## **Development Review Comments**

March 14, 2023 PAM2023-00145

## Submission Review Comments 2401 Wootton Parkway – Rockshire Village Center

SHEET NO. SP-1

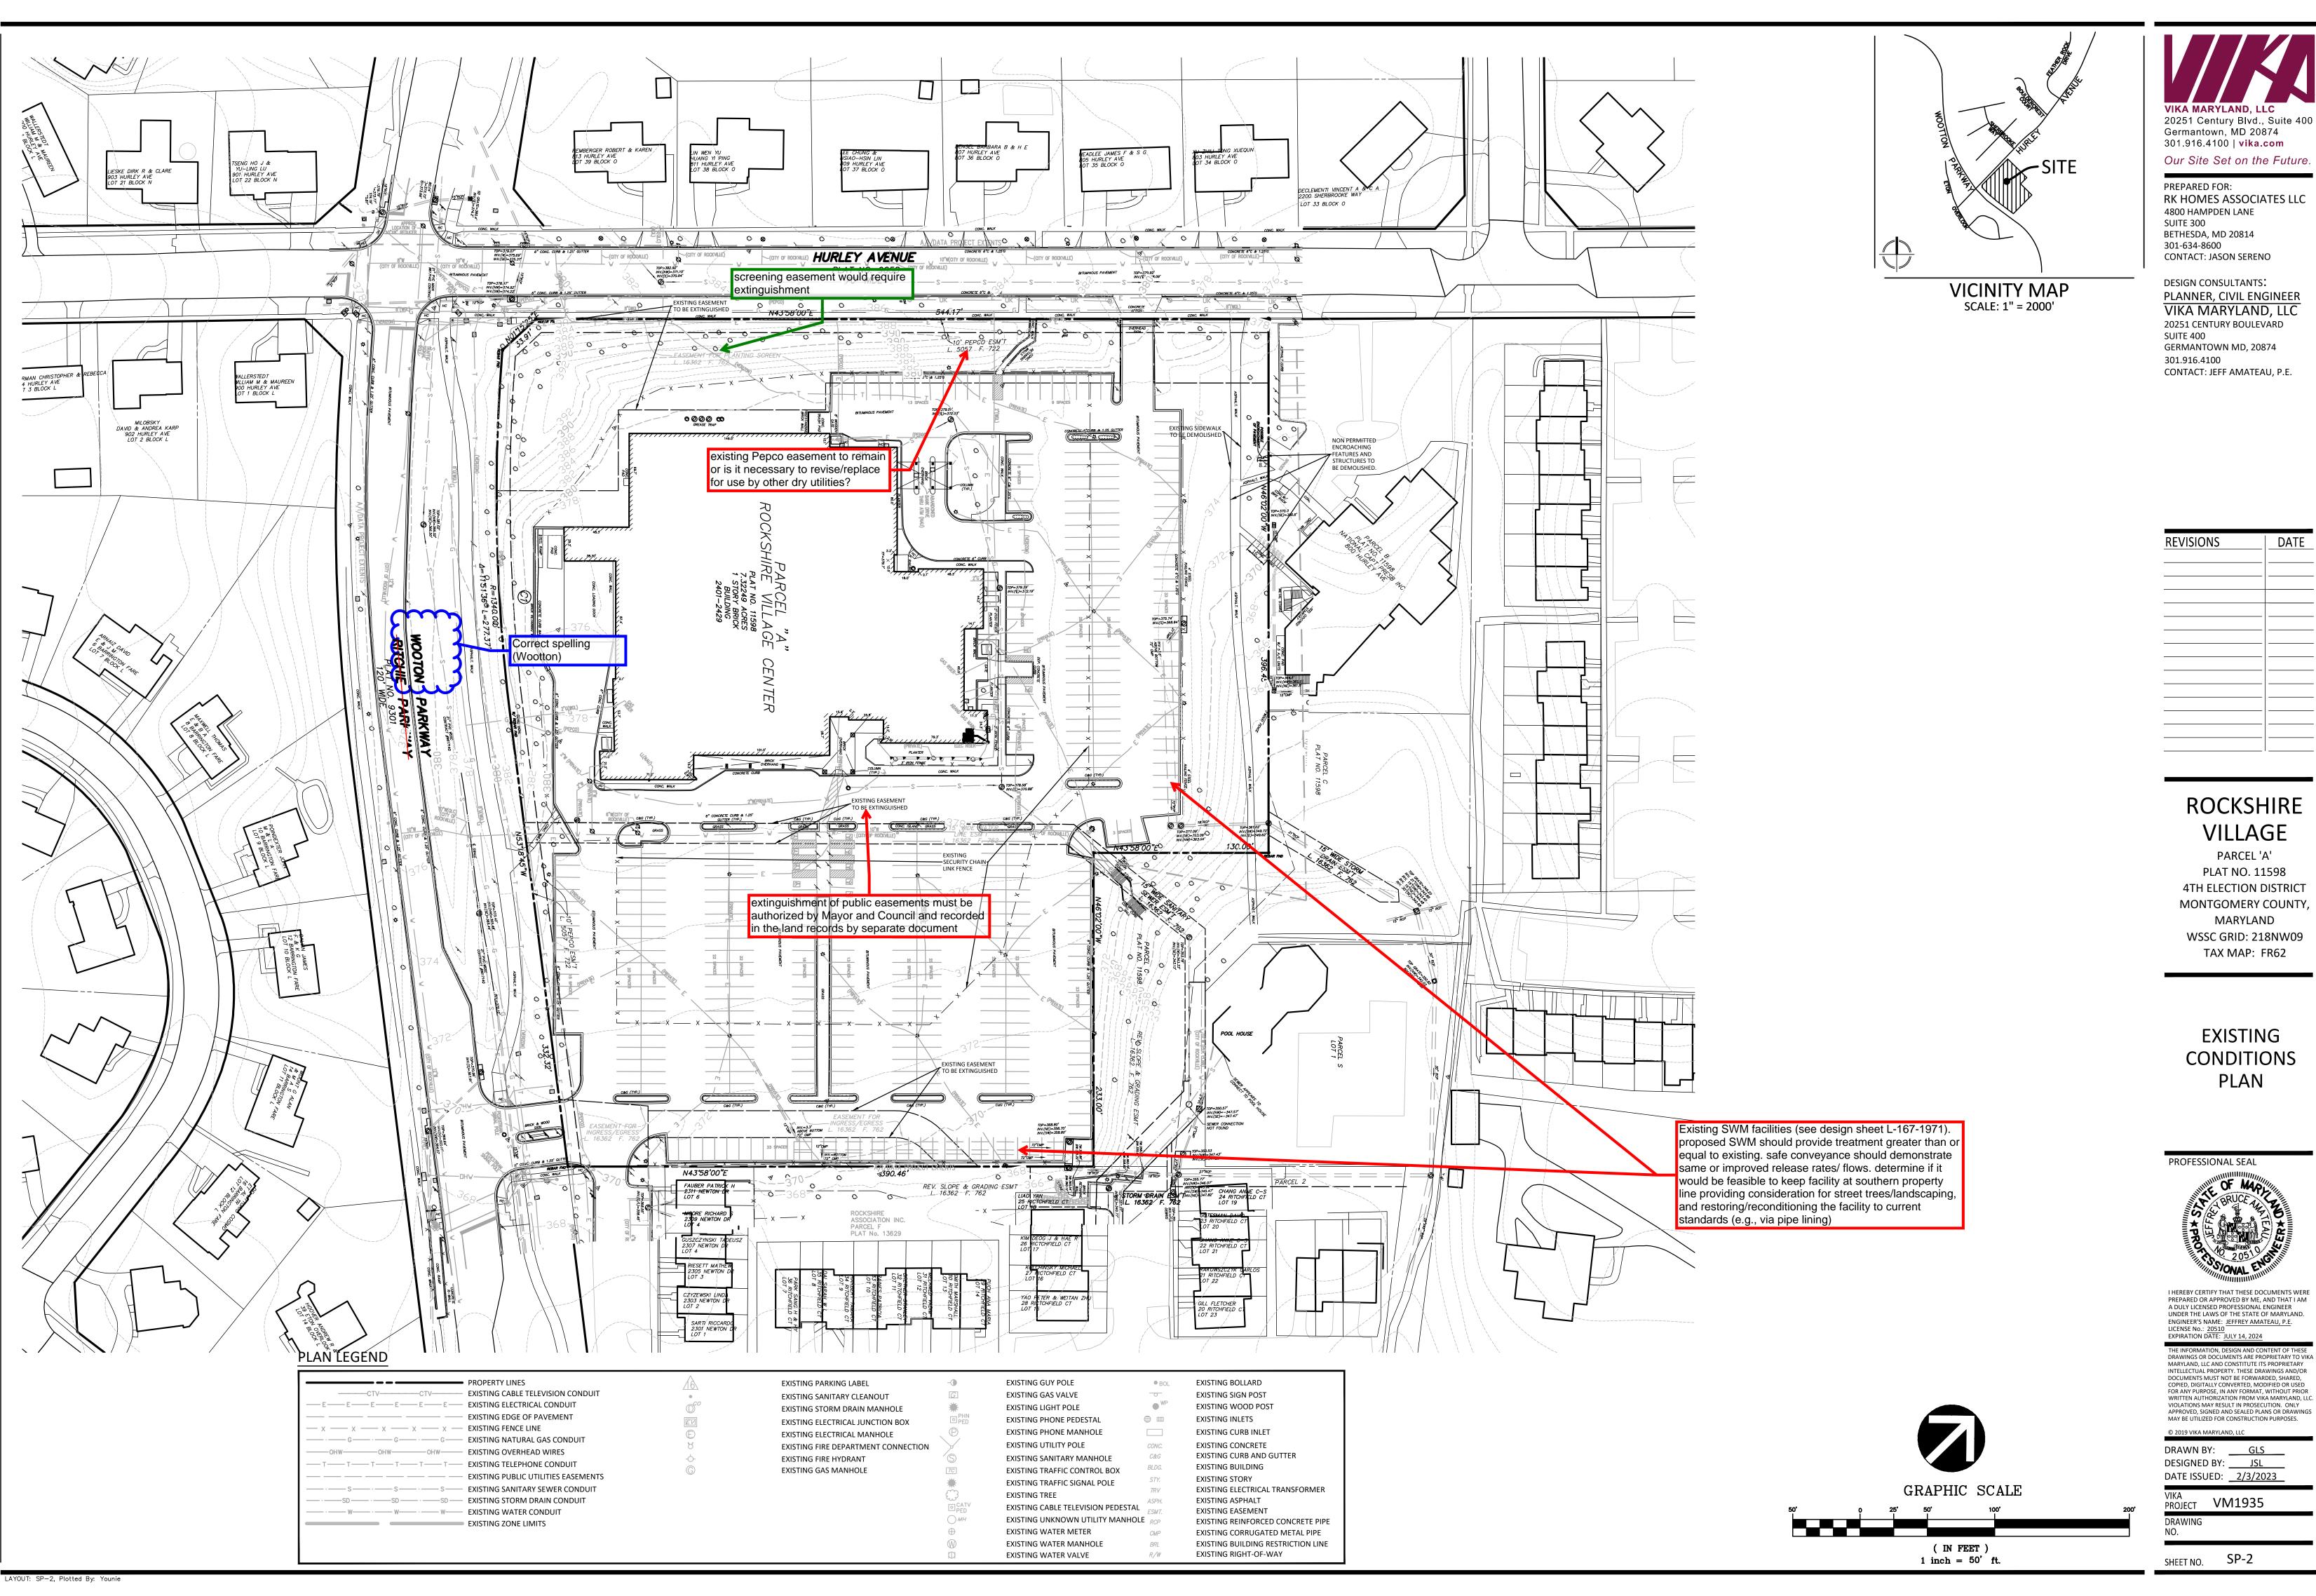
Design street parking for the subdivision so that it does not violate the provisions of Section SITE PLAN 23-26 of the city code.

Ensure proper spacing between parking and crosswalks and traffic control like stop signs. Bikeway Master Plan calls for Shared roadway on Hurley and Millenium Trail on Wootton.

City staff suggests putting together a limited signing and marking plan with the application For future signing and marking plans, include submittal, showing elements that might have an sharrows on property side of the frontage on mpact on the parking locations in order to Hurley Avenue, and on Streets A and B. demonstrate code compliance.

asement widths should be able to provide enough space to construct, maintain, and vehicle access. Widths must be able to meet OSHA excavation requirements.

It is recommend that adequate easements be provided for retaining walls.

Provide layout per ordinance 25.17.03a. All underground lines and cables shall be placed in a public utility easement, or otherwise on private property. No utilities may be placed in the public right-of-way or on City property without the express written permission of the City, and subject to such terms and conditions that the City may require.

Dry utilities may cross the ROW perpendicular Applicant shall submit a conceptual dry utility plan to be approved by both the utility companies and DPW.

A Water & Sewer Authorization must be approved prior to Site Plan approval. Submit completed Water & Sewer Authorization application with applicable fees.

b. Generally dead-end water mains should be avoided. c. The City generally follows WSSC Pipeline Design Manual for sizing, structures, clearances,

d. Public water and sewer mains should not be located within SWM easements. e. extension of the existing 10" water main (that currently services the shopping center) is required.

the on-site system must be a public, looped system that preferably connects to Hurley Ave

Pre-App SWM Concept must be approved prior to submission of the Development SWM Concept Site Plan cannot be submitted until the Pre-App SWM Concept is approved. •The Pre-App SWM Approval letter will establish the study points of the safe conveyance analysis.

Preliminary Sediment Control Plan must be approved prior to site plan approval.

•Development Stormwater Management Concept must be approved prior to site plan approval

Safe Conveyance Study must be approved prior to site plan approval. The Pre-App SWM Approval letter will establish the study points of the safe conveyance analysis. However, this analysis may be concurrent with the Development SWM Concept.

– 62' RIGHT OF WAY – Add 5 foot wide sidewalk per standard detail 45A. this section will then match middle section +0.58'-EX. GRADE @ ELEV. VARIES SECONDARY RESIDENTIAL ROAD SLOPES AS SHOWN IN SITE

visitor parking exceeds 0.5space/ DU

reference City standard detail 45A, secondary residential road section

provide cross section for alleys

> SITE PLAN 30 SCALE

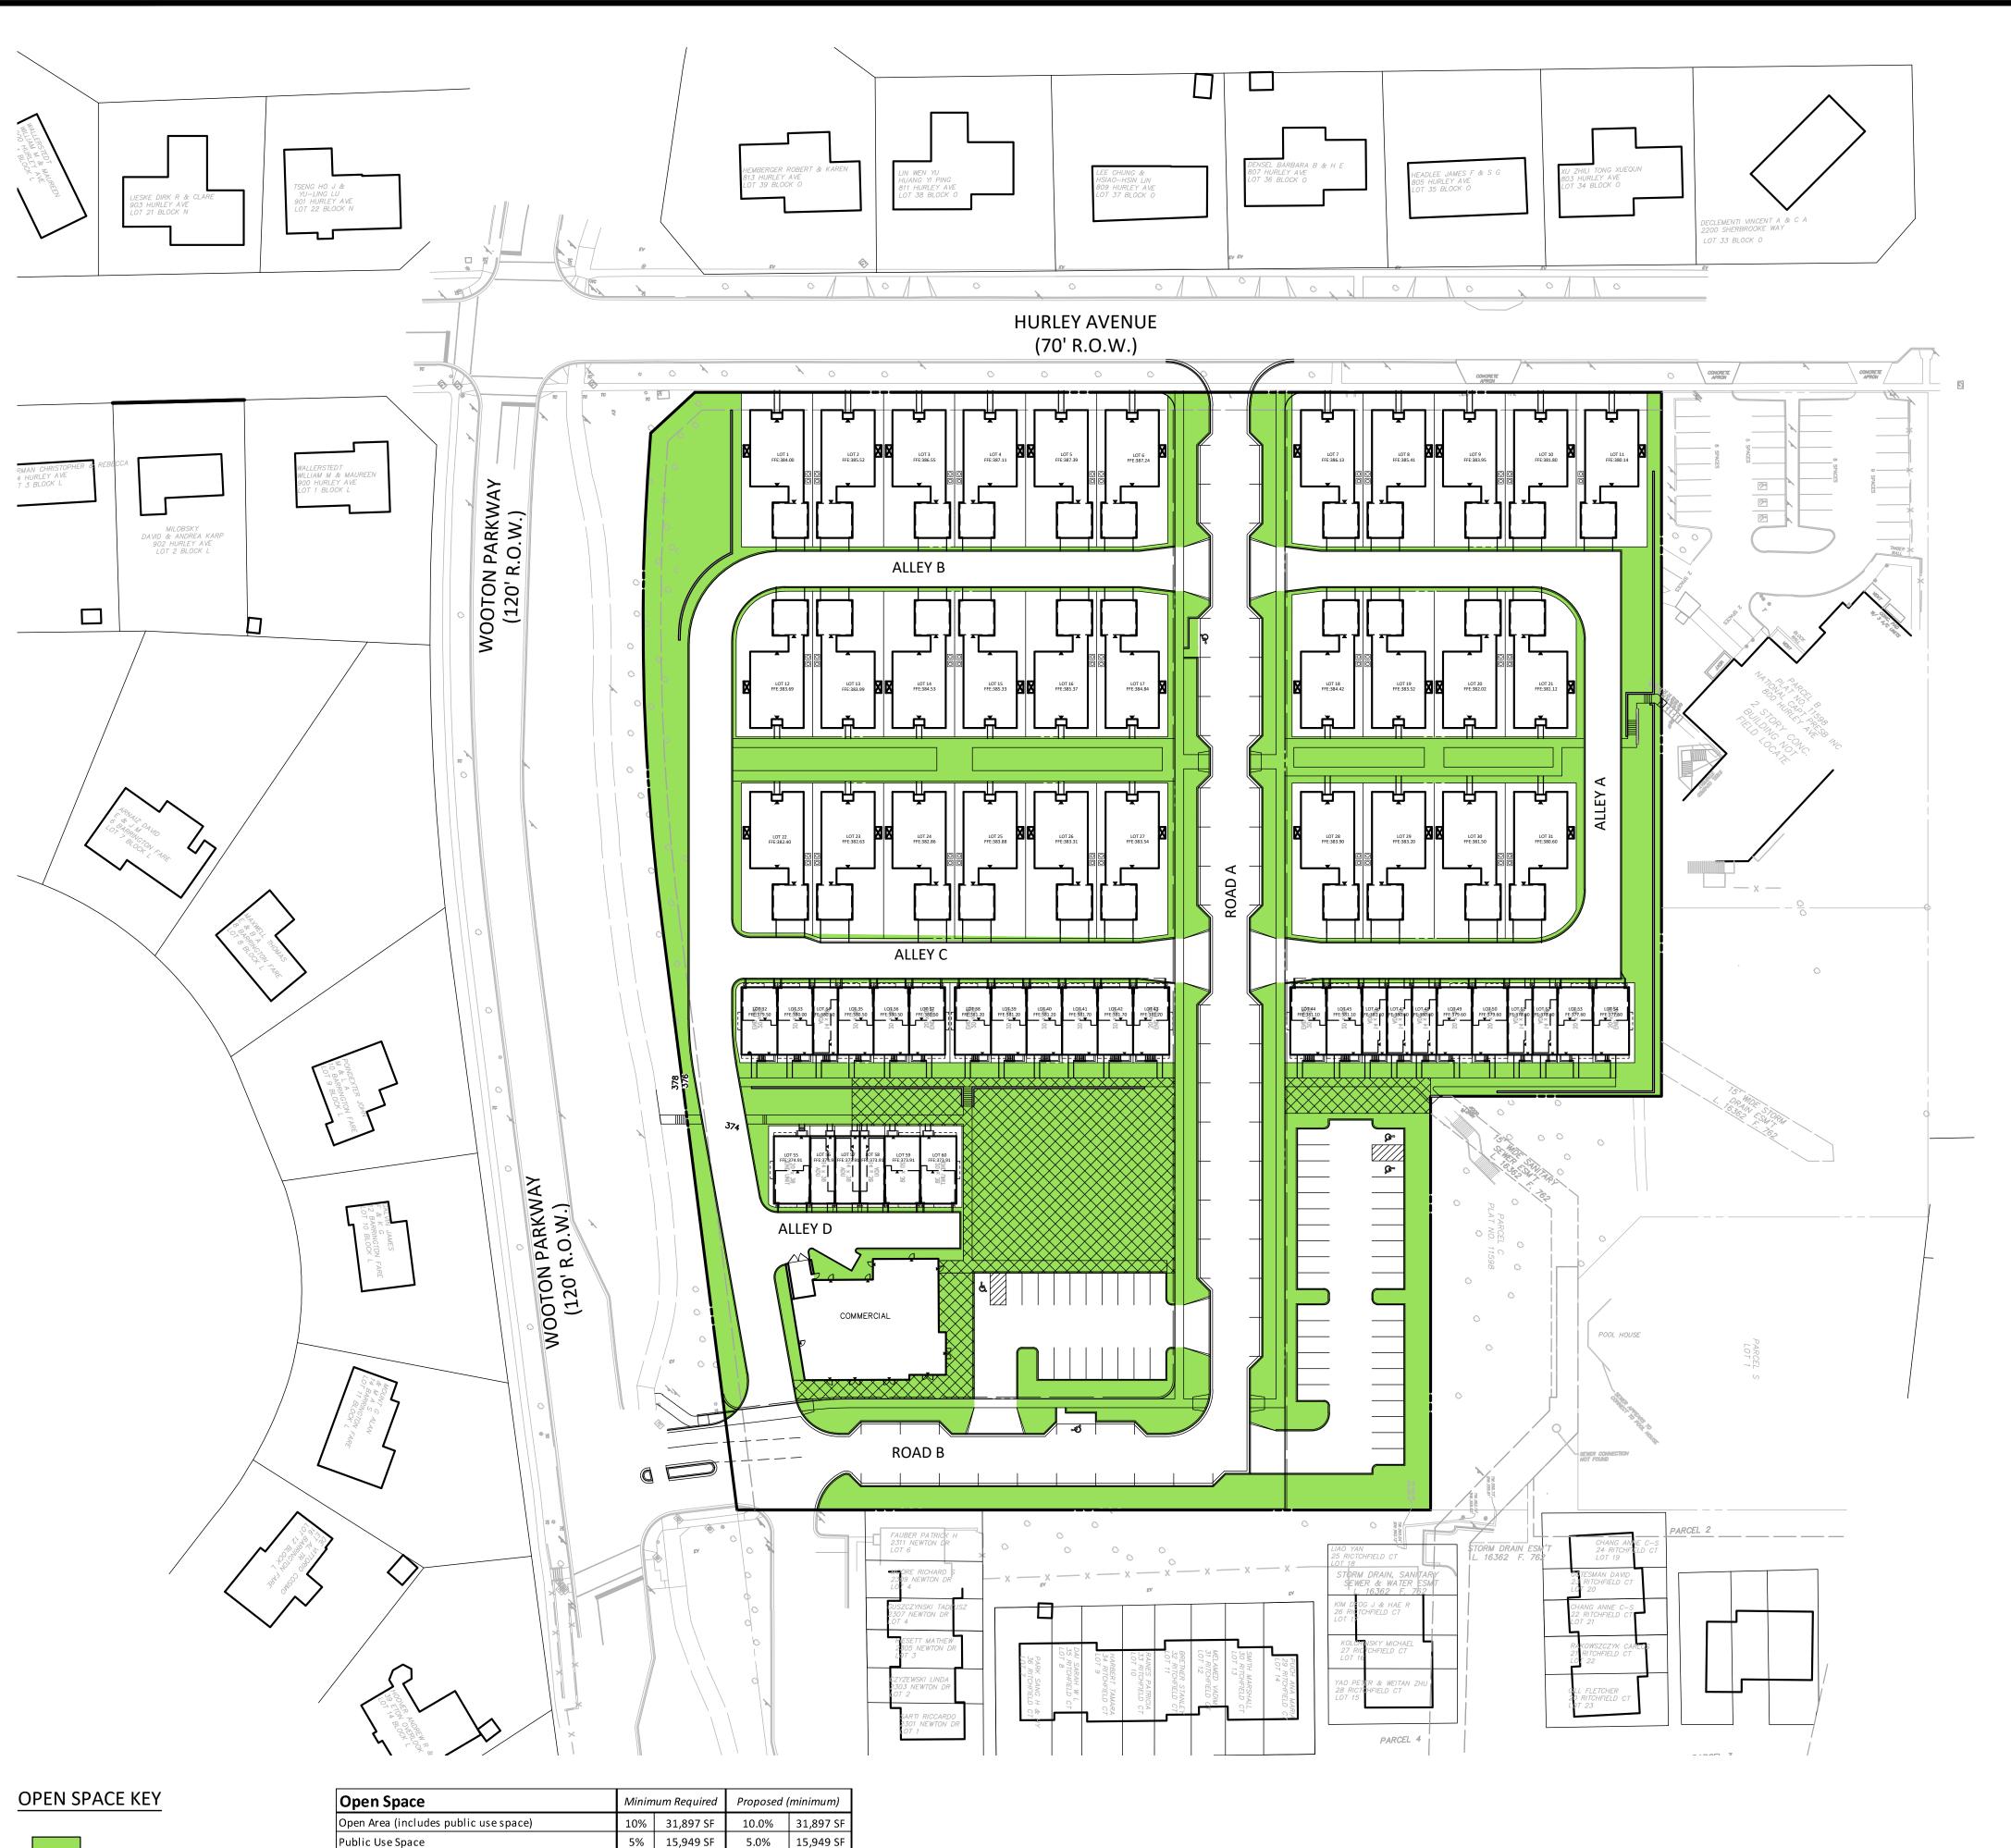
Plan is showing dry utility meters in rear

how are lots 55-60

served by dry utilities?

tree/ sewer conflict

Fire - turning radius

verify condition of ex. 10" W is acceptable prior to reuse

Loading spaces are required to be on

(25.16.04.a) and shielded from view of residential properties (25.13.06.c.7)

Dead-end alley is still an issue which will require a waiver from the M&C.

2. Eliminating one unit and provide

3 provide connection to Street B

1. Eliminating two units

Recommend:

Show sidewalk along A

Analyze sight

Parking not permitted

clarify WHC design. if proposing

recommend

relocating ADA

parking to retail lo

justify why the grade differences are

utility infrastructure should not be

Sec. 25.16.06.a.4 - Parking design

Provide a ped connection between the parking

extend public main on-site and loop to Hurley Ave. refer to
